LOCATION Ramp 407 EW to 400 South  
over Ramp EW to S (Bridge #20)

FOUNDATION INVESTIGATION REPORT  
for  
BRIDGE #20  
HWY. 407 EW - 400 S.B.L.  
W.P. 138-87-09, Site 37-1183  
District #6, Toronto

RE: Preliminary Drawing Review  
Ramp 407 E, W to 400S Over  
Steeles Ave. E, W to 400 S, Bridge #20  
W.P. 138-87-09, Site 37-1183, Dist. #6

RE: Preliminary Drawing Review  
Ramp 407 EW to 400 S Over  
Ramp Steeles Avenue EW to 400 S  
Site 37-1183, W.P. 138-87-09  
Highway 400, District 6

ABUTMENT ON COMPACTED FILL  
SHOWING GRANULAR 'A' CORE

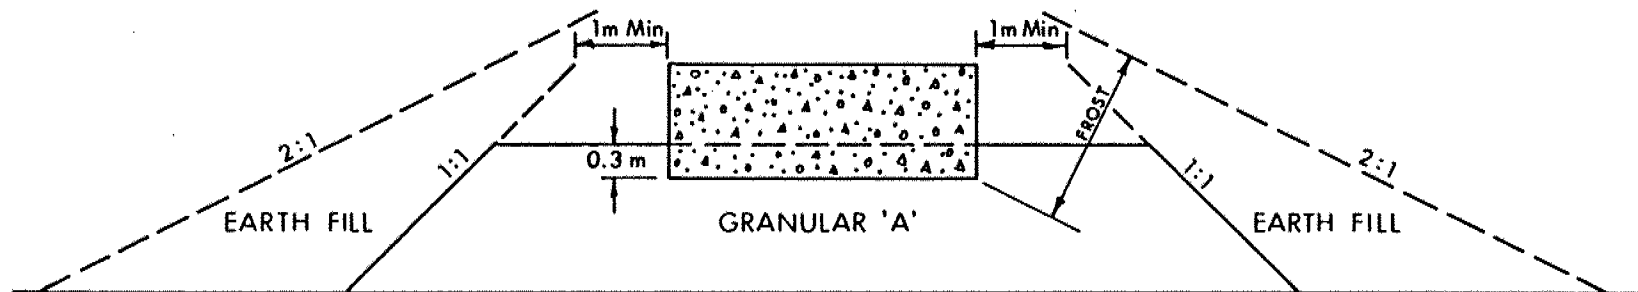
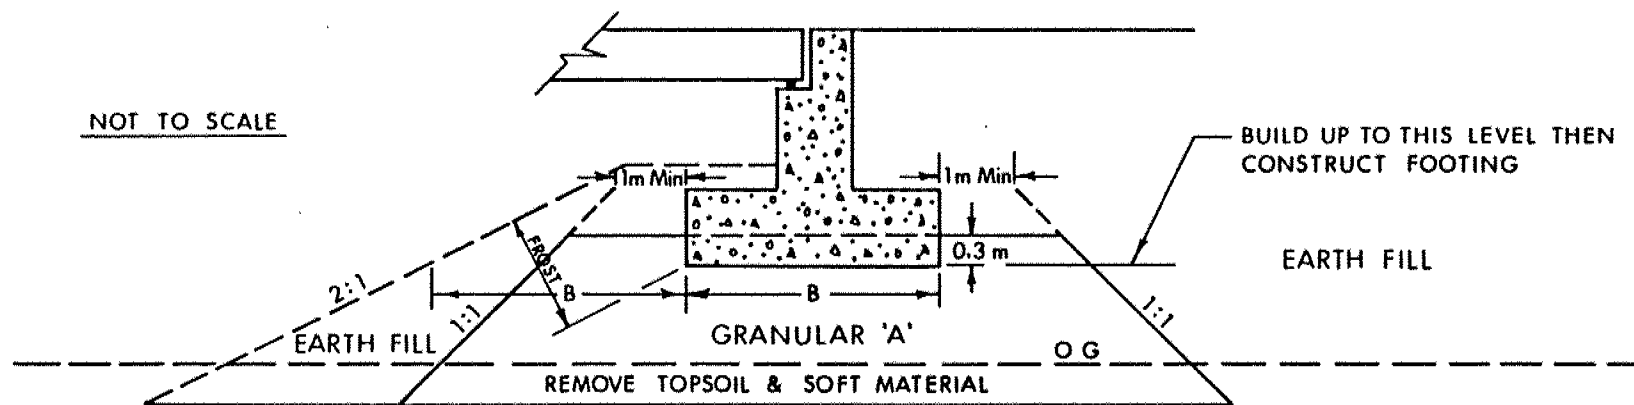
The abutments may be founded on compacted granular 'A' fill. The fill is to be constructed in accordance with figure 3, with side slopes at a minimum of 1H to 1V in all directions, and compacted in accordance with OPSS 501.

South West Wing Wall

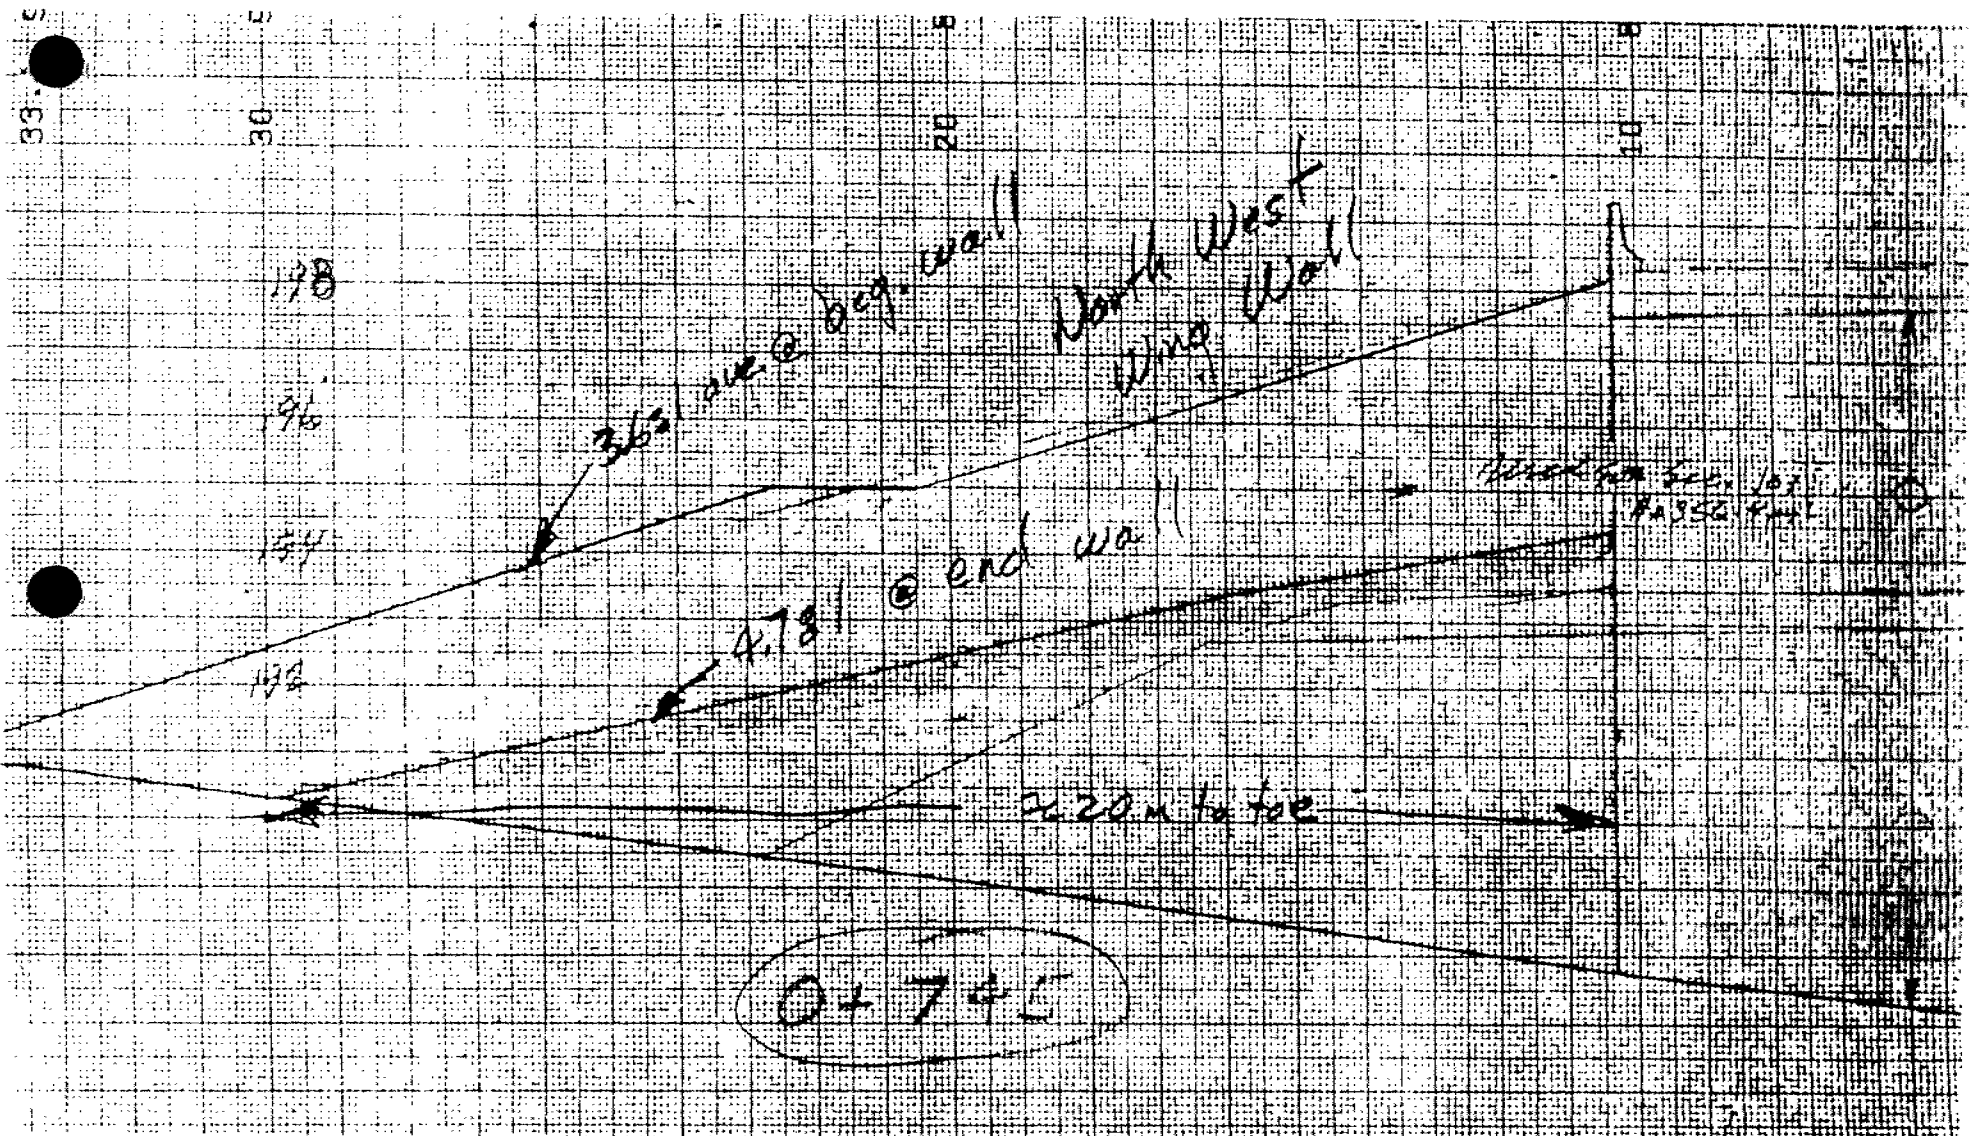
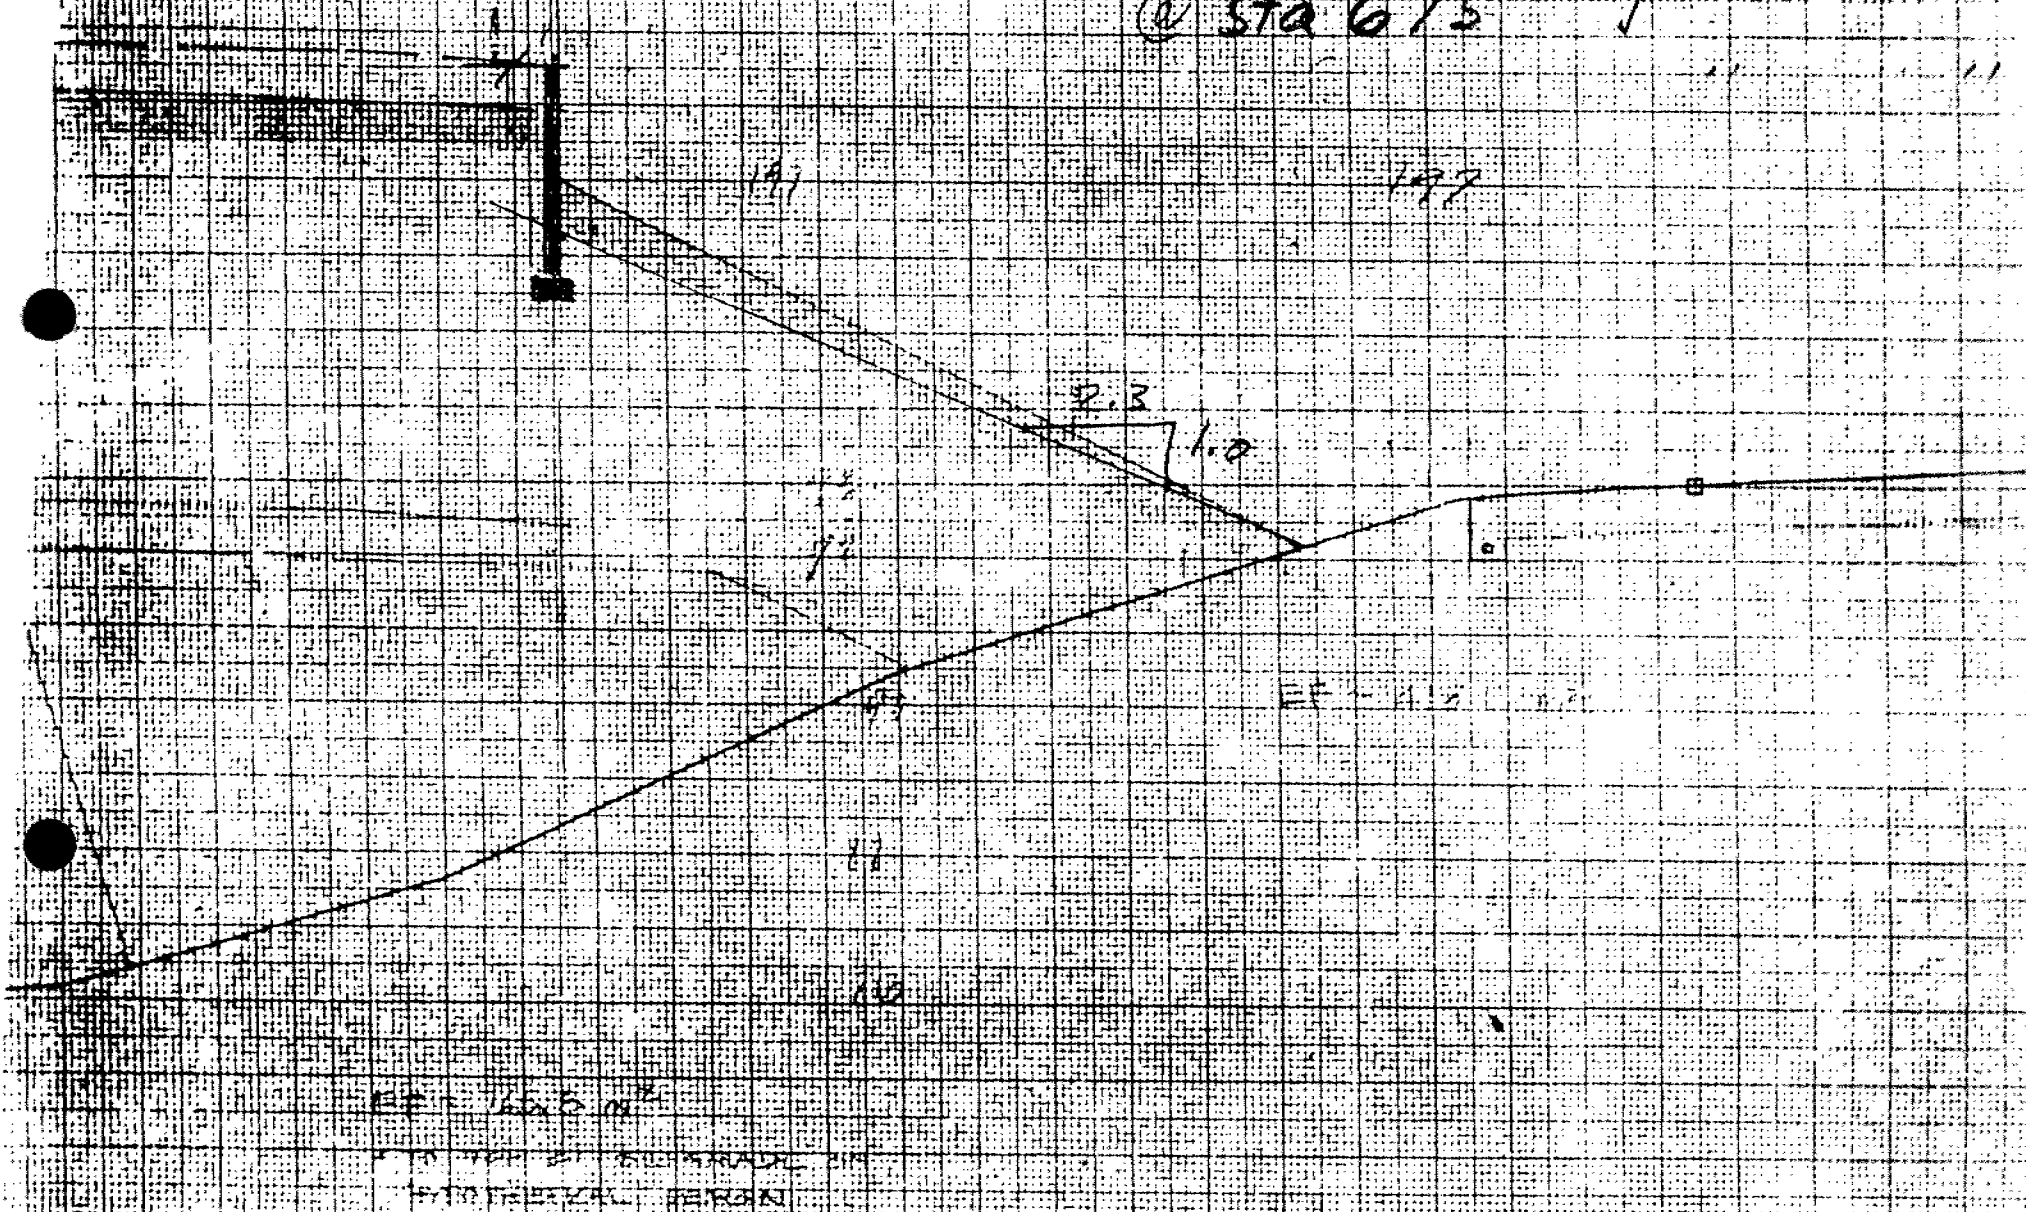
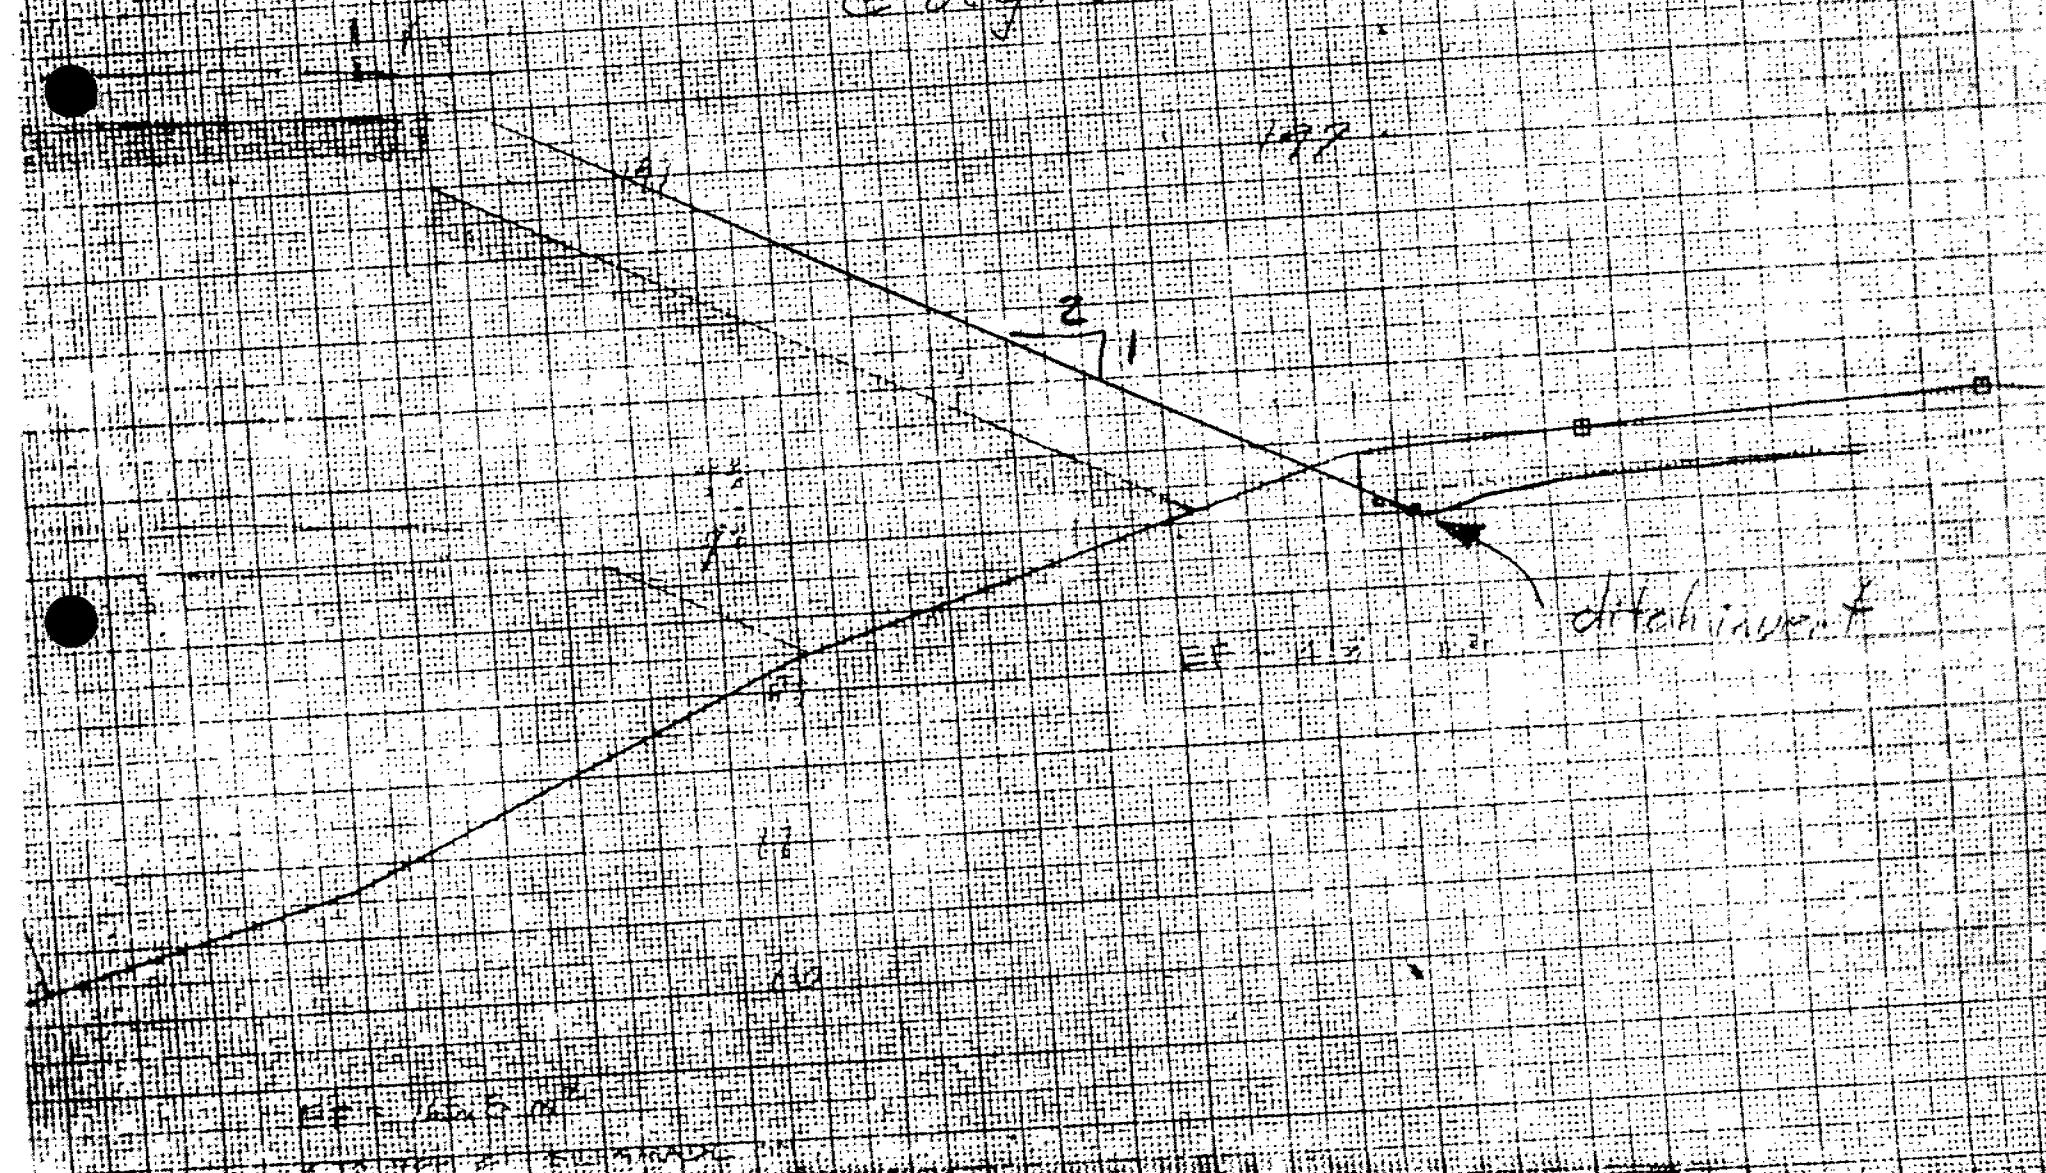
In response to your memo dated 89/02/09, I have reviewed the sections provided and as mentioned, the slopes are indeed flatter than 2H:1V for all walls except the southeast. Consequently, prefabricated walls of shorter heights can be applied provided these heights are provided with required base covers. To clarify this intent I have provided a table that summarizes calculations for various wall heights and forward slopes. This table shall be used in coordinating the heights of your walls. Please contact me if there is any difficulty in the interpretation of the results.

In response to your Fax concerning the geometry and configuration of the aforementioned walls, I am returning the submitted elevation that illustrates the necessity for the forward slopes (Section A-A'). The forward slopes should be no steeper than 2.5H:1V and the design should be coordinated and integrated with the Steeles Ramp to 400 S.

Fig. 1

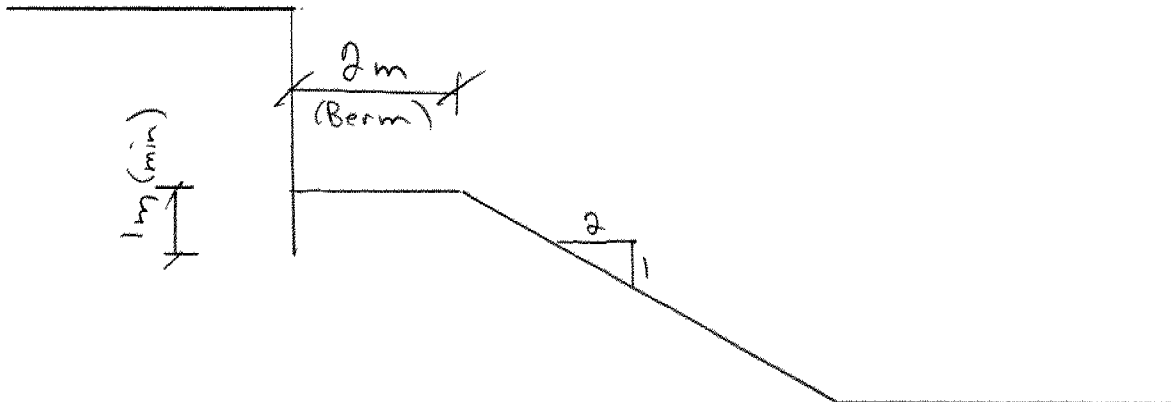
2m nominal berm constructed a  
minimum 1m above the reinforced  
earth levelling pad. (see Fig 1 below)  
All slopes are 2H:1V.
